GEORGE M.
JANES &
ASSOCIATES

April 8, 2021

RE: Zoning Challenge
1299 Third Avenue
Block 1429, Lot 4
Job No: 121187964

Elevation illustrating the size of the cantilever relative to the base and the neighbors

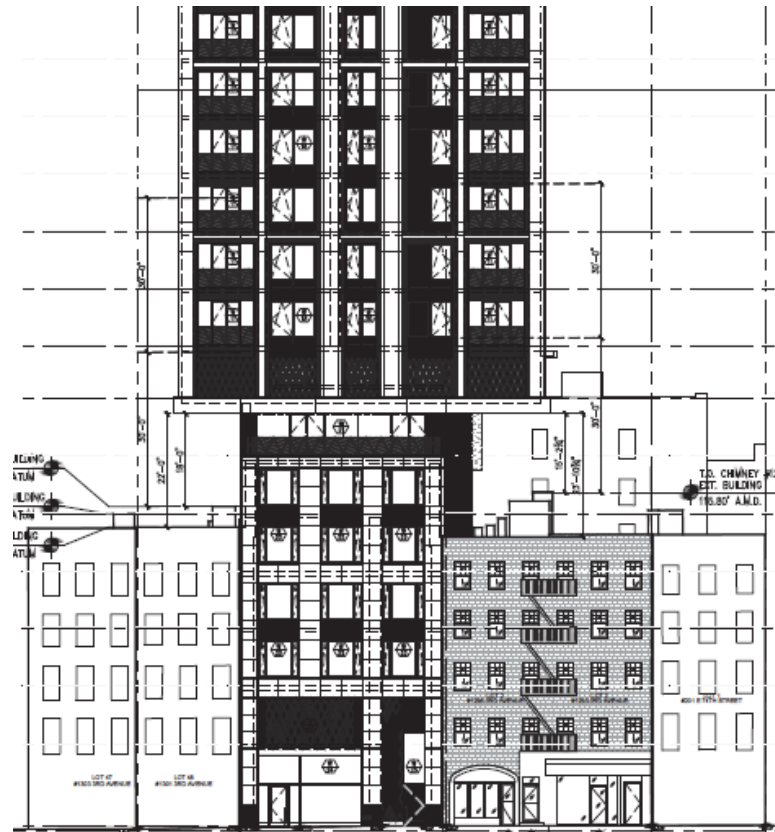
The northern one extends 12 feet over lot 48 and the southern one extends 19.17 feet over lot 2. The building's base fronts Third Avenue for 40 feet. The cantilevers extend the width of the tower portion of the building to 71.17 feet, which allows the tower to be about 78% wider than it could be without the cantilever. This is the largest cantilever on the Upper East Side and one of the largest in New York City.

Detail of North-South and East/West Sections from Z-006. The seventh floor is highlighted.

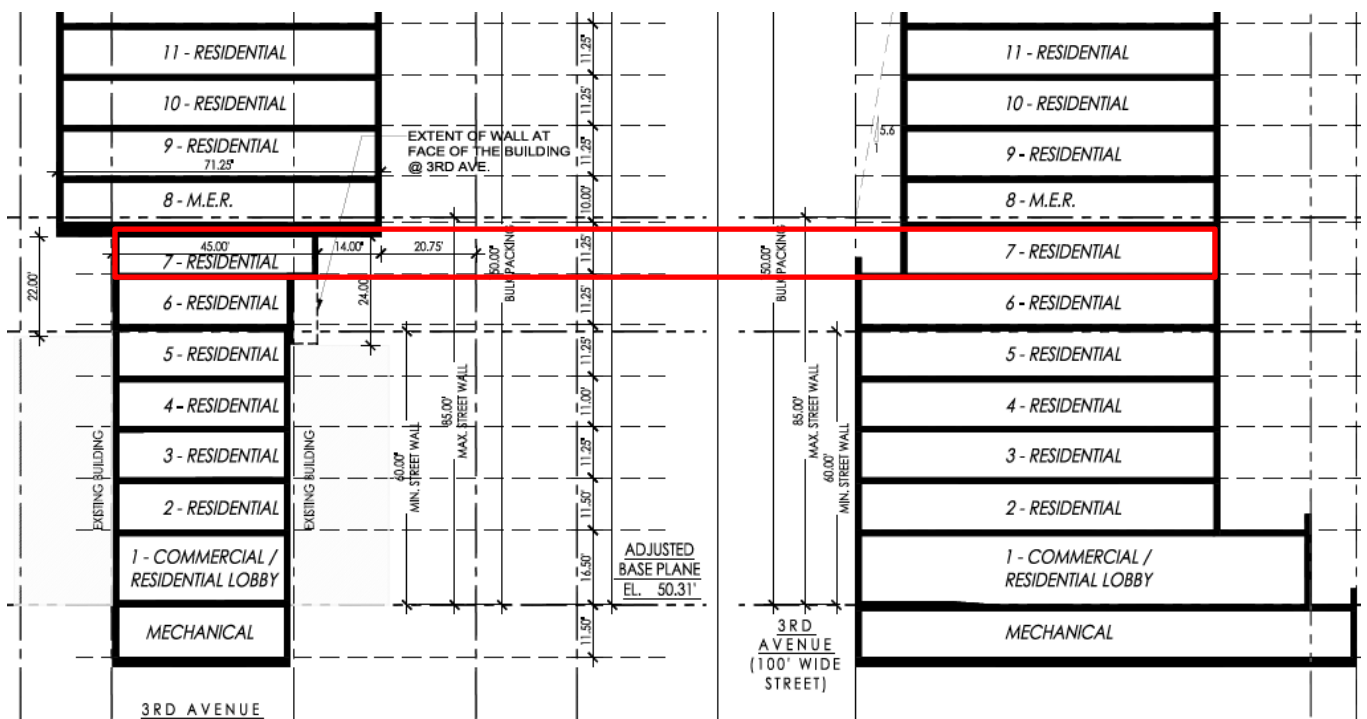
All of the seventh floor of the proposed building is setback 10 feet from the street line, so it does not qualify as being part of the base. The base rises up from the streetline to the sixth floor and entirely sets back at the seventh floor. The seventh floor, therefore, is a tower floor, as defined by 23-651.

Tower-on-a-base requires that tower floors have a minimum tower coverage of 30% (23-652). The C1-9 portion of the lot is 12,270 SF. Thirty percent of that is 3,681 SF, but the 7th floor is 3,118 SF, or just 25.4%. This tower floor is too small and does not comply with the requirements of a tower floor that is not located at the top of the building.

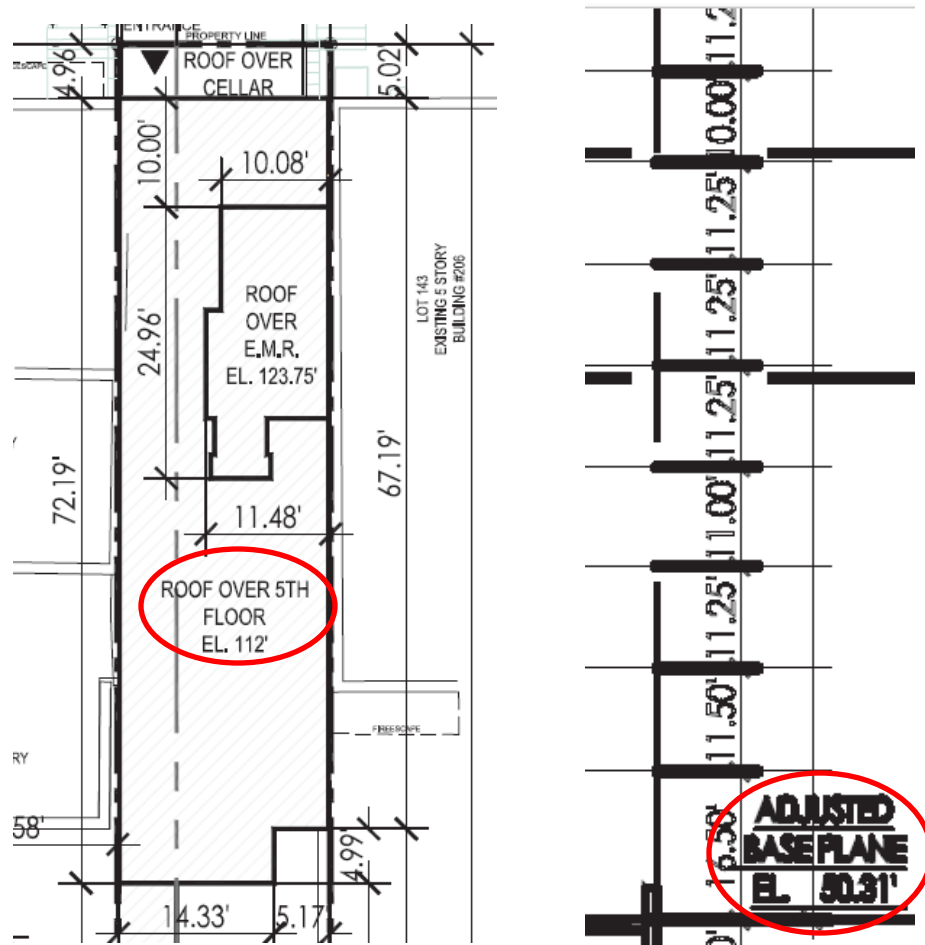
From the ZD1, the 32nd floor is 2,200 SF. The floor beneath it (the 31st floor) is 2,711 SF. Eighty percent of 2,711 is 2,169 SF. The 32nd floor is 42 SF too large.

The applicant ignored this floor in sheet Z-006 where compliance is shown for this provision. They might be thinking that the 32nd floor -- which is identified as such on the ZD -- is not a story. However, the definition of "story" in the Zoning Resolution is extremely broad:

The 32nd floor is clearly a story and is too large to comply with ZR 23-651(a)(1)(ii).

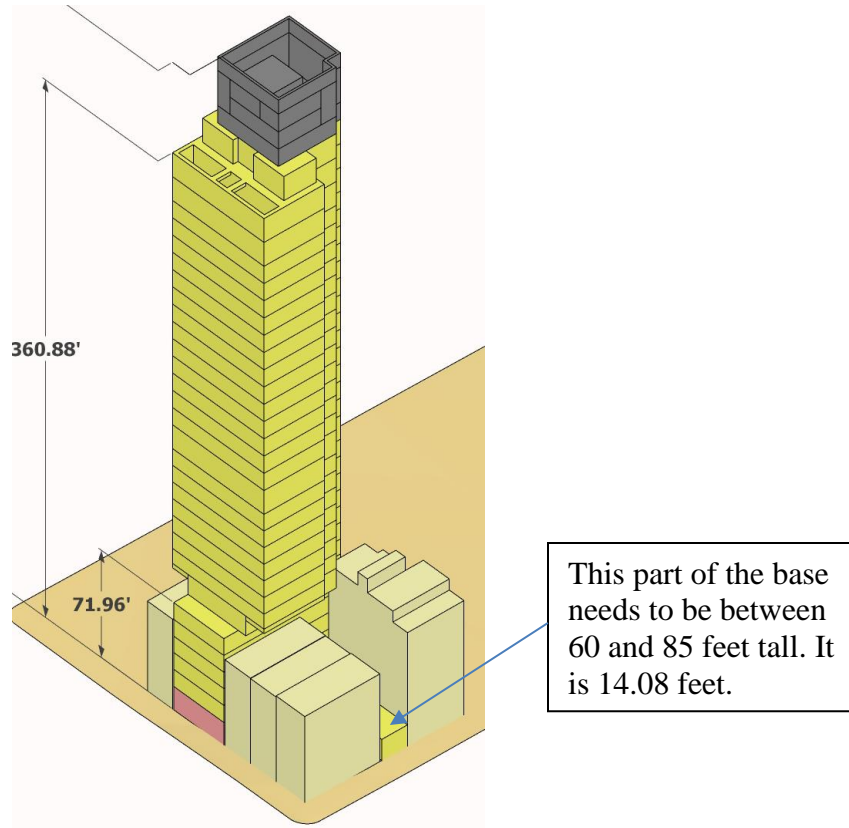
The problem is with the one-story portion that fronts 74th Street. While 23-651 makes some allowances for recesses, under no circumstances can a base height be 14 feet tall, as is the base height of the portion that fronts 74th Street.

The 17.85 foot wide base that fronts 74th Street is 14.08 feet tall and 100 percent of the aggregate width exceeds a depth of eight feet. The following axonometric image illustrates where there is a problem with the base:

A plan view of floors 17 through 23 with walls facing Third Avenue, color coded by width (top) and a legend for the color and the amount of green wall deduction taken by this one wall segment (bottom left). A detail of the French door wall on the right. Most of this wall is open air.

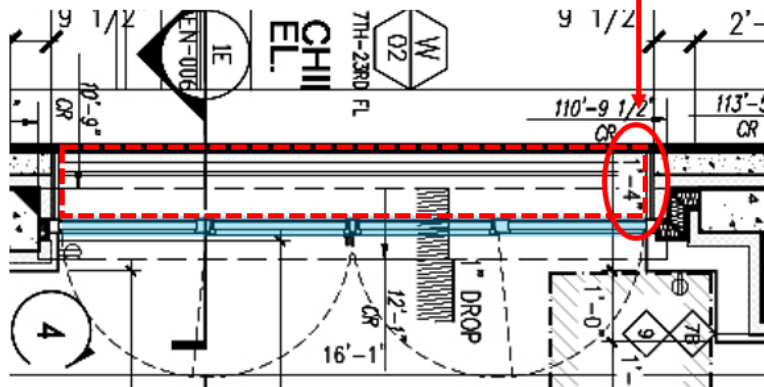
The purple portions of the wall are thick and easily qualify. The red portions of the wall are 13.75 feet, which means 5.75 inches can be deducted. The green portions of the wall are 9.1 inches, which means 1.1 inches can be deducted. The blue portions of the wall note a floor-to-ceiling French door which is just 3.4 inches wide. Since it is less than 8 inches, none of it can be deducted.

The applicant is claiming 46.56 SF deduction for this one wall for this one floor, taking the full eight inches, even though most of this wall does not qualify for the full deduction. When the math is done on the wall thickness calculated by segment, just 18.21 SF can be deducted, a 61% reduction in the floor area exempted. If other floors are similarly overstated, this building is easily out of compliance with the maximum floor area for the lot, considering the thousands of square feet taken in green wall deduction.

The applicant needs to properly take deductions for actual wall thickness. The green wall deduction is not a bonus to compensate for energy efficient walls, the walls actually have to exist at their required thickness. The Department should rescind the approval.

23-651(a)(3) MIN. 57.5% OF TOTAL FLOOR AREA LOCATED BELOW HEIGHT OF 150'

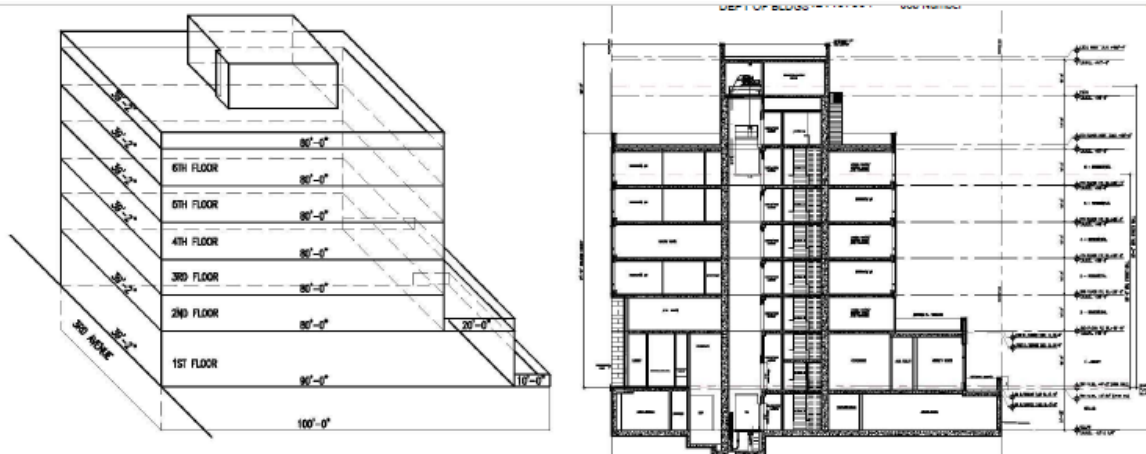
On page Z-006, however, floor area in the C1-9 district changes to 146,105 SF to show compliance with the tower-on-a-base calculations.

This is not a rounding error and brings into question the building's compliance with the bulk packing requirements of the tower-on-a-base regulations.

The applicant is correct in saying that tower coverage requires that 57.5% of the floor area on the lot must be under 150 feet. But if we were to correct the floor area for the deductions taken but not itemized, which are mostly above 150 feet, the building does not comply with having 57.5% of the floor area under 150 feet. In other words, if pages Z-010 through Z-017 are correct, the building does not comply. If the building summarized in Z-001 is correct, then it does. The Department needs a set of plans that are internally consistent to demonstrate compliance.
